ADDENDUM NUMBER 1

PROJECT TITLE:
CHILLER REPLACEMENT - RIVERPLEX

ISSUANCE DATE: 1 August 2019

LOCATION: **RIVERPLEX RECREATIONAL & WELLNESS CENTER**
600 N.E. WATER STREET, PEORIA, IL 61603

CHILLER SCREEN DETAIL ELEVATION

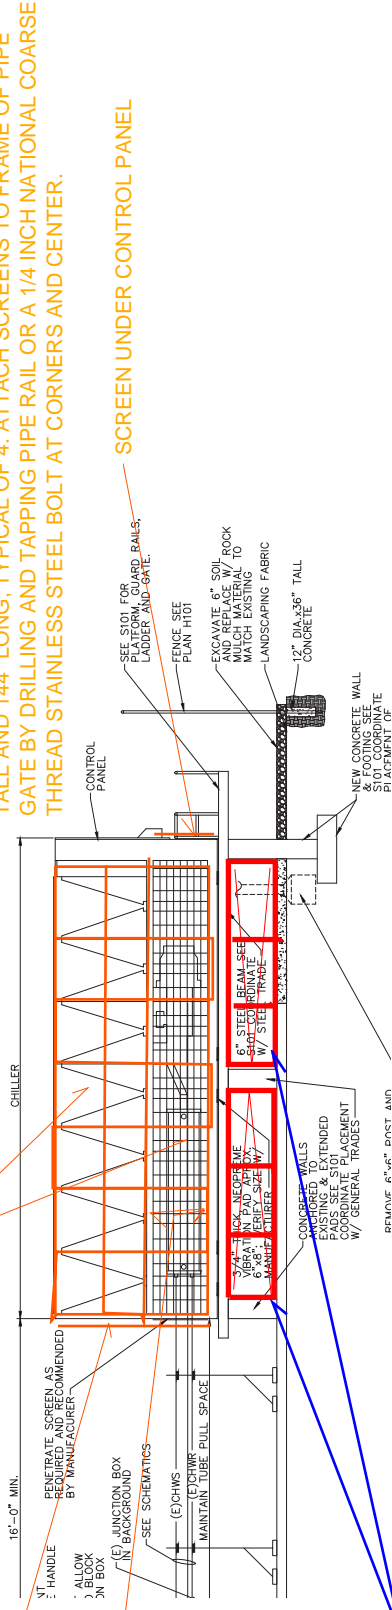
FABRICATED "COTTONWOOD" SCREENS OF NO.10 316 STAINLESS STEEL MESH WITH MINIMUM OF 67.2% CLEAR OPENING. HEM EDGES WITH DOUBLED 1" WIDE X 24 GAUGE 316 STAINLESS STEEL. ATTACH TO EXTERIOR SURFACE OF MANUFACTURER'S HAIL GUARD, WITH NO 8 STAINLESS STEEL DRIVE SCREWS. PROVIDE INTERMEDIATE SUPPORTS ON NO GREATER THAN 32" CENTERS WHERE HAIL GUARD IS NOT PROVIDED. MATCH HEM LENGTHS TO STRUCTURE OF HAIL GUARD. MAXIMUM SIZE OF FABRICATED SCREENED AREA IS 300" LONG X 100" HIGH ON SIDES AND 88" LONG AND 100" HIGH ON ENDS, FOR THE CHILLER ITSELF. VERIFY ACTUAL DIMENSIONS PRIOR TO FABRICATION. SCREENS ON DEMOUNTABLE GATES SHALL BE ROUGHLY 36" TALL AND 144" LONG; TYPICAL OF 4. ATTACH SCREENS TO FRAME OF PIPE GATE BY DRILLING AND TAPPING PIPE RAIL OR A 1/4 INCH NATIONAL COARSE THREAD STAINLESS STEEL BOLT AT CORNERS AND CENTER.

SIDE SCREENS

END SCREEN

SCREEN DIMENSIONS AROUND EQUIPMENT ACCESS SHALL MATCH EQUIPMENT ACCESS HEIGHT. DOUBLE HEMS AS REQUIRED.

SWINGING OR DEMOUNTABLE GATES ON BOTH SIDES. PROVIDE HINGES AND LATCH AND END SUPPORT AS 14 GAUGE TO 1/4" THICK MOUNTING PLATES ANCHORED TO CONCRETE WALLS, WITH A MINIMUM OF 4- 3/8" CONCRETE ANCHORS. PROVIDE CHAIN LINK FENCE FABRIC CLIPPED IN CENTER OF PIPE.
